# CITY OF ALBUQUERQUE

**RE: US Eagle FCU – Juan Tabo  
1955 Juan Tabo NE  
Grading and Drainage Plan Stamp Date: 11/21/19  
Hydrology File: H21D029**

Based on the submittal received on 12/16/19, the Grading and Drainage Plan cannot be approved until the following are corrected:

SHEET NUMBER: C-101

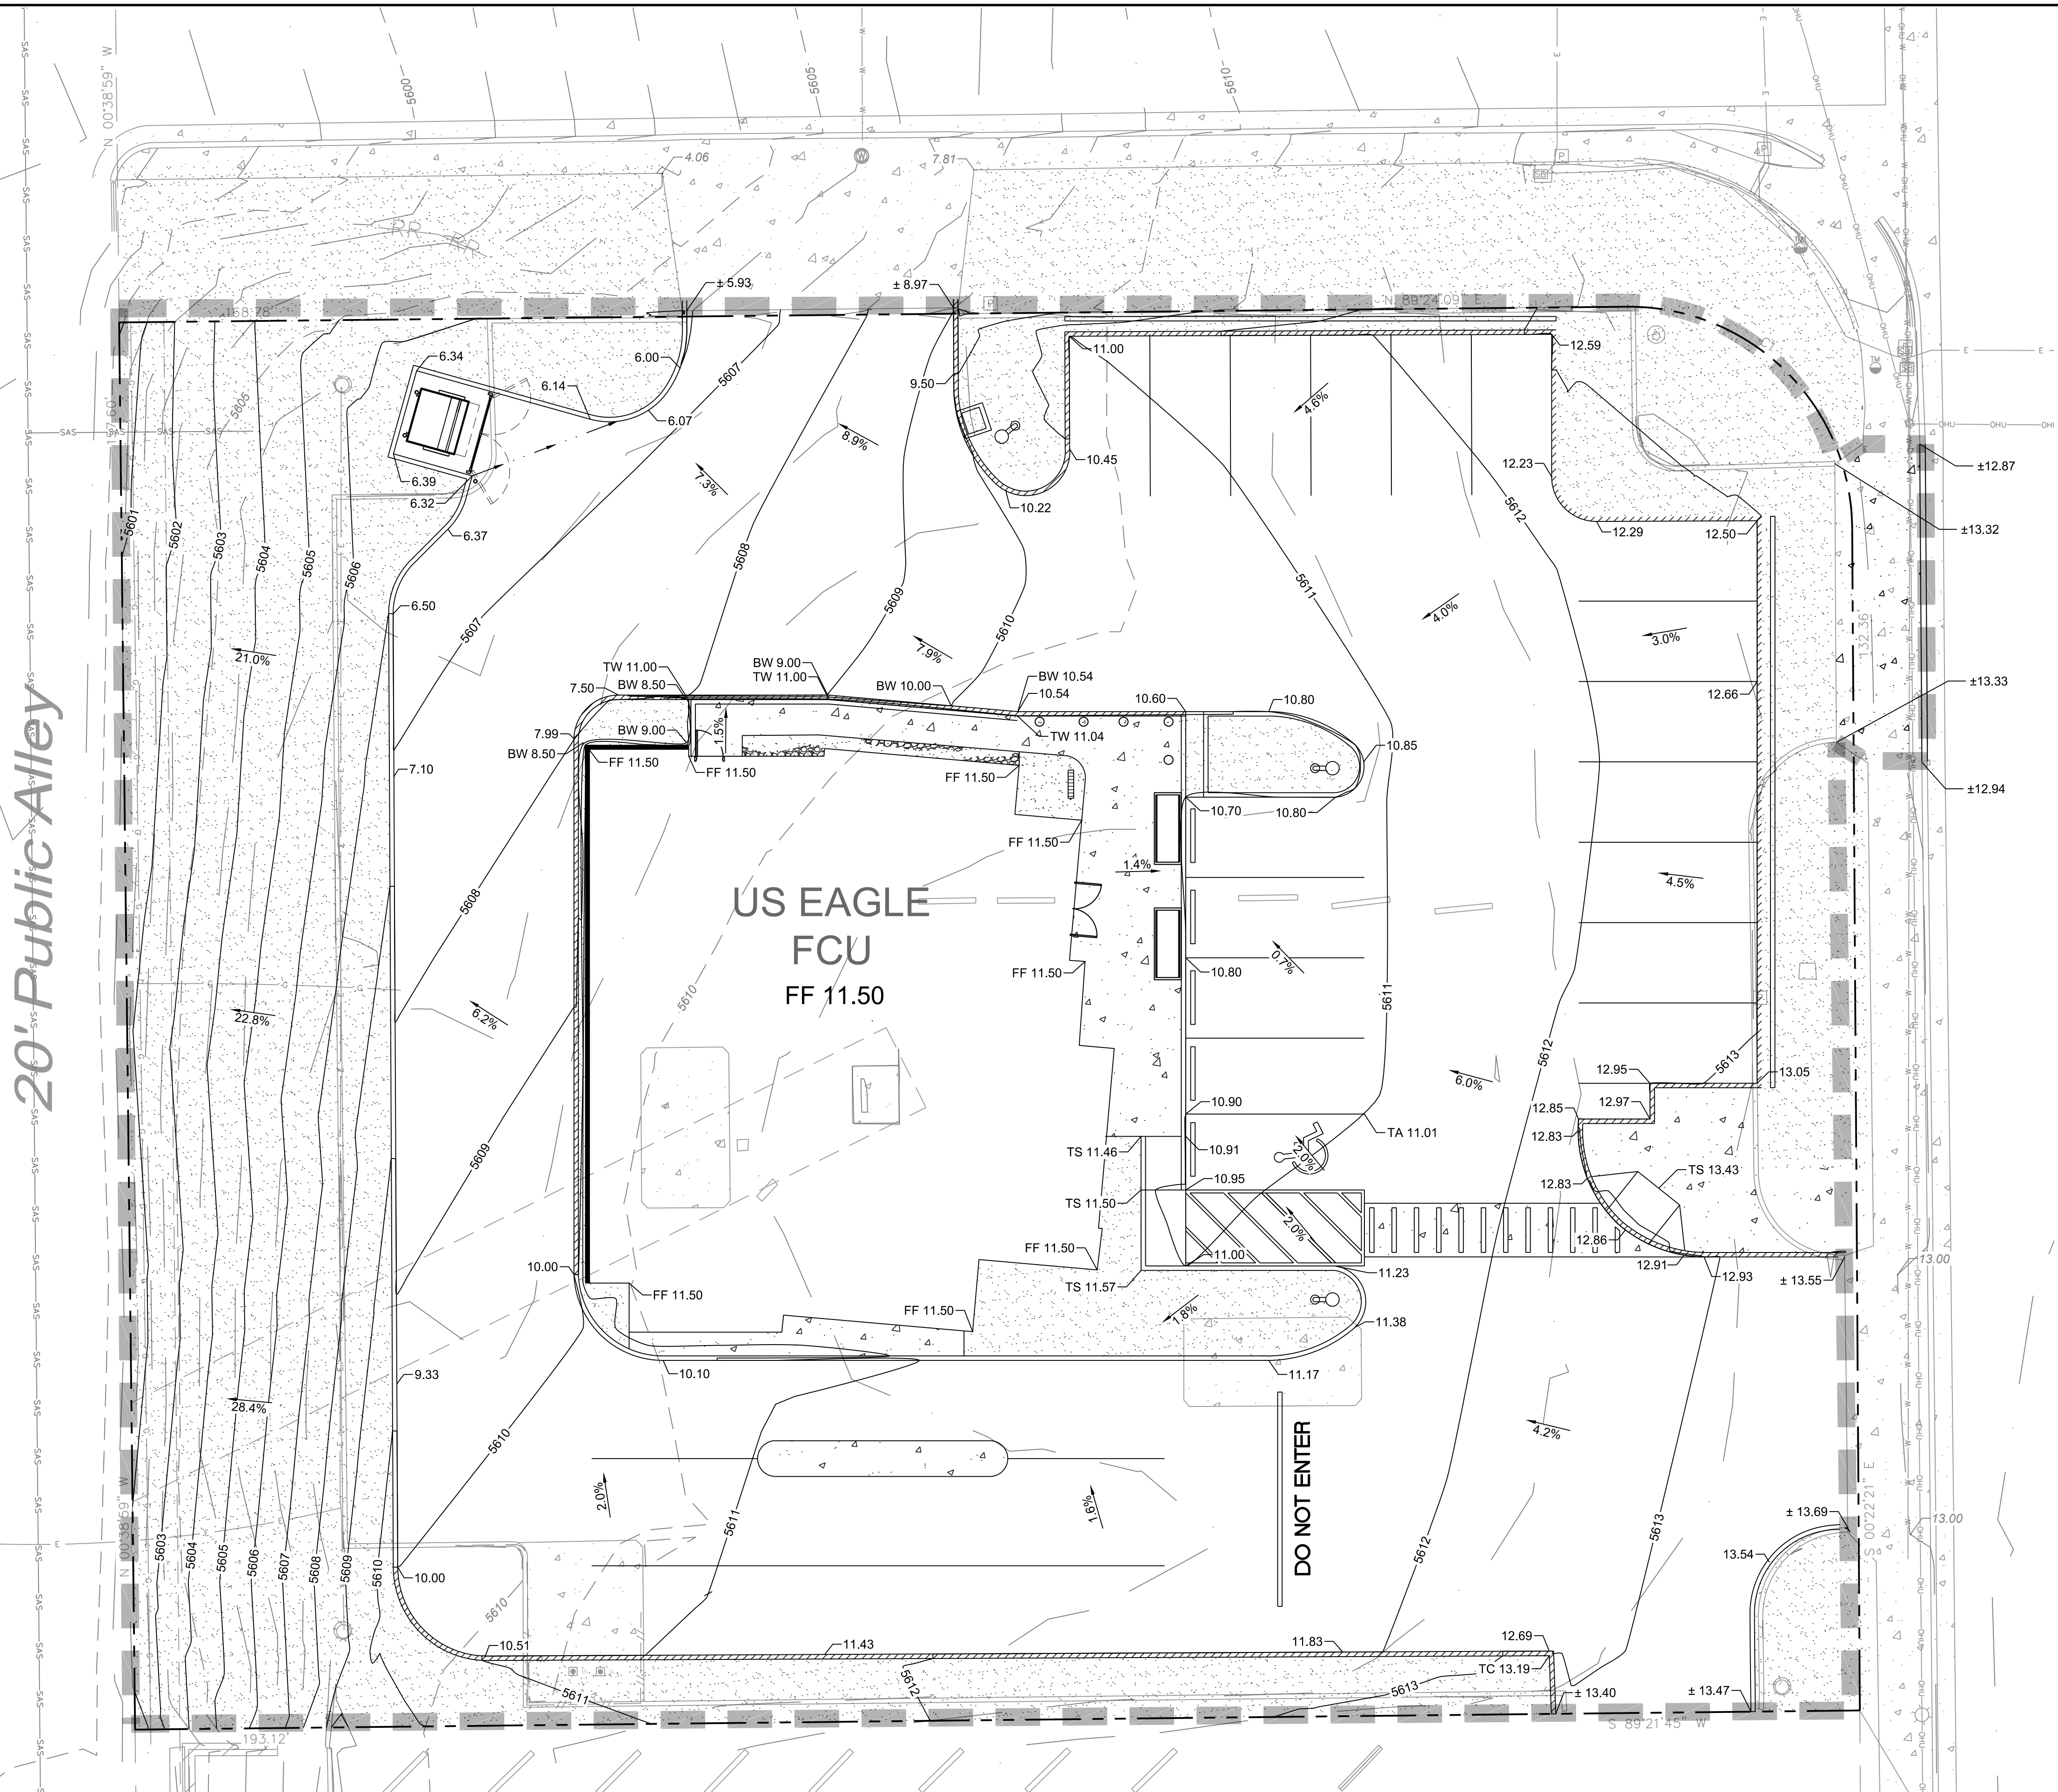
1. This site qualifies as redevelopment and is only required to retain runoff from the 80<sup>th</sup> percentile storm ( $\text{Vol.} = 0.26'' * \text{Imp. Area}$ ); calculations need to be corrected to reflect this.
2. A waterblock, 0.87' high, per COA Paving Detail No. 2426, is required at the driveway entrance (Juan Tabo side).
3. Show the grading and paving for rebuilding the alley.
4. If only seeking Site Plan for Building Permit approval at this time, label the grading plan "Conceptual, Not For Construction" or similar and address the SPBP comments. If seeking SPBP and Building Permit simultaneously, forgo the conceptual markings and address all SPBP and Building Permit comments.

5. Payment in Lieu (Amount =  $481\text{CF} \times \$8/\text{CF} = \$3848$ , per sheet C-101) of onsite management of the SWQV must be made. Take three copies of the treasury deposit slip to the Treasury and then include one copy of the paid deposit slip when resubmitting.
6. As a reminder, if the project total area of disturbance (including the staging area and any work within the adjacent Right-of-Way) is 1 acre or more, then an Erosion and Sediment Control (ESC) Plan and Owner's certified Notice of Intent (NOI) is required to be submitted
